## AGENDA

2. ACTION: Recommendation to review and provide direction on the Design Review and Townhouse Preliminary Plat applications for the townhouse development at 310 Georgia Road. - Associate Planner, Paige Nied

STAFF REPORT  
KETCHUM PLANNING AND ZONING COMMISSION  
REGULAR MEETING OF APRIL 15, 2026

PROPOSED DECK - RESTORED OUTSIDE OF FLOODWAY

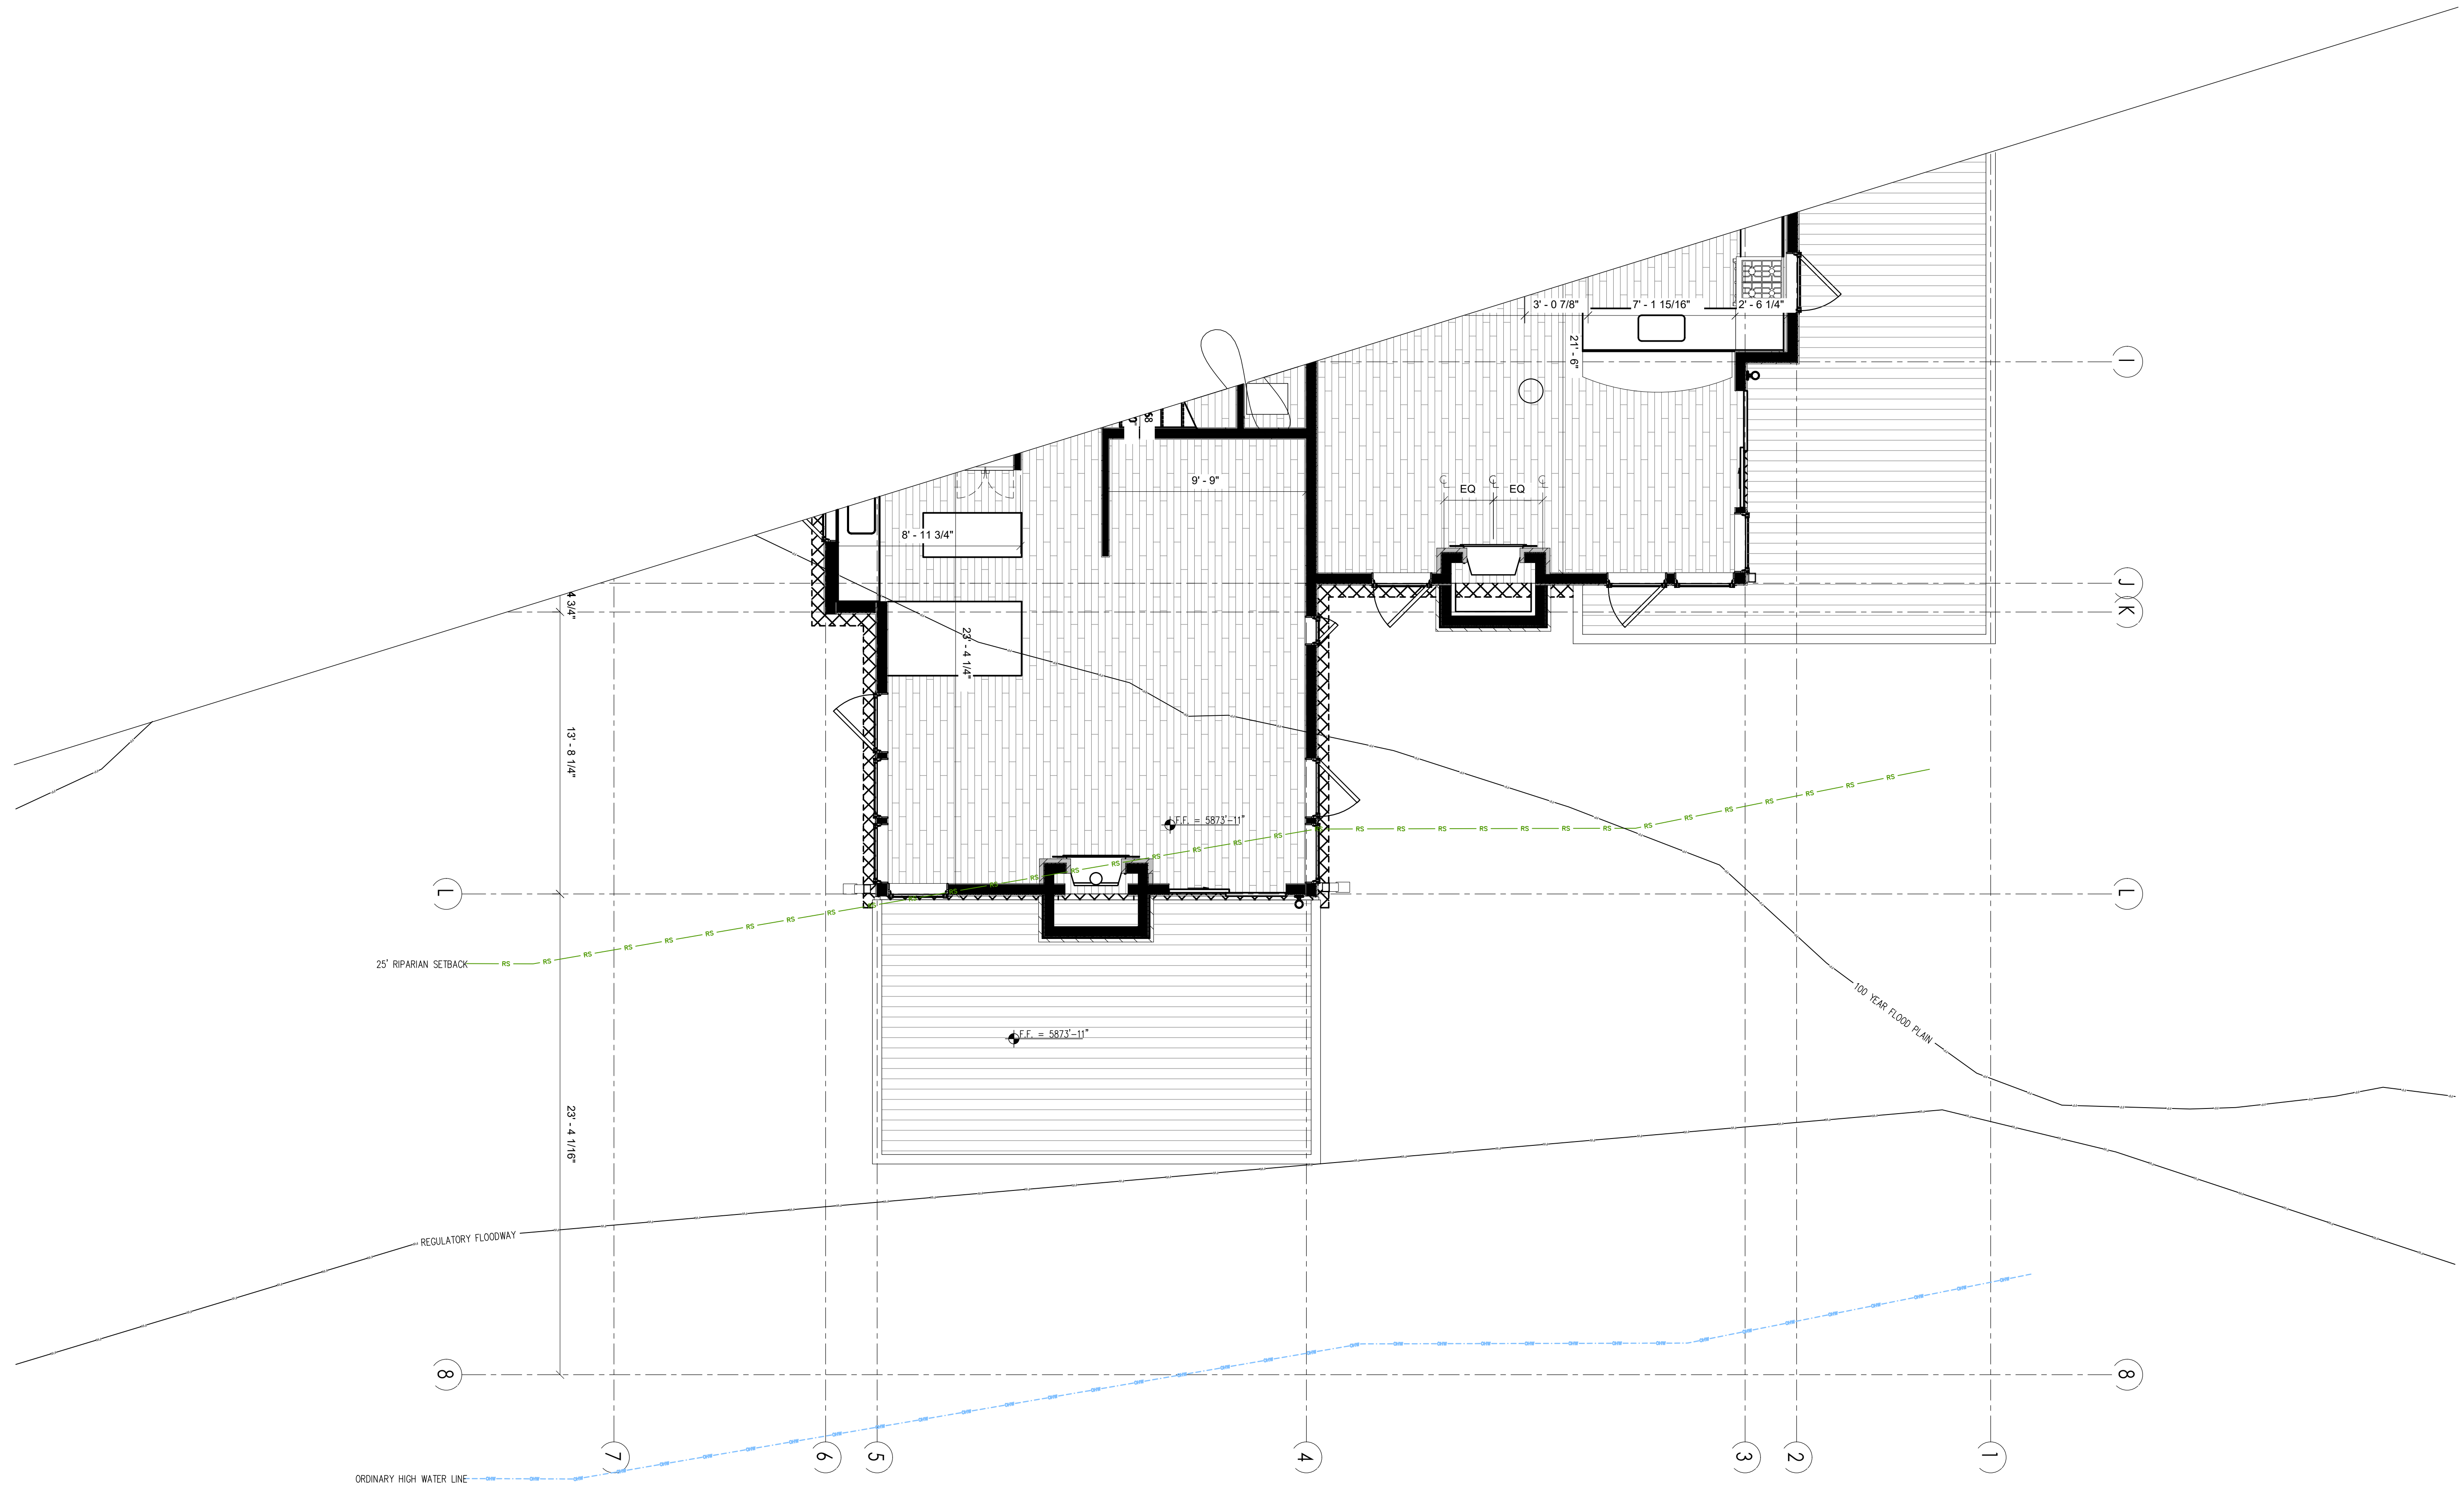
1	Comment: See comments related to resubmittals requested for the Floodplain Permit #P25-63 from Sarah Foster, Floodplain Manager. In addition, a deck determination letter will be made available from the Administrator with the direction <b>to omit the deck from the building permit set p. C0.20, A1.0, to be removed from the riparian setback excepting the landing.</b>
	Applicant Response:
2	Comment: See comment from Wastewater Department. The preexisting footprint of the structure is located 10' on top of the city sewer line. This is simply to make the property owner aware of the circumstance. Further conversations may be needed internally on how to best proceed if rerouting the line is necessary and/or feasible at this time.
	Applicant Response:
3	Comment:
	Applicant Response:
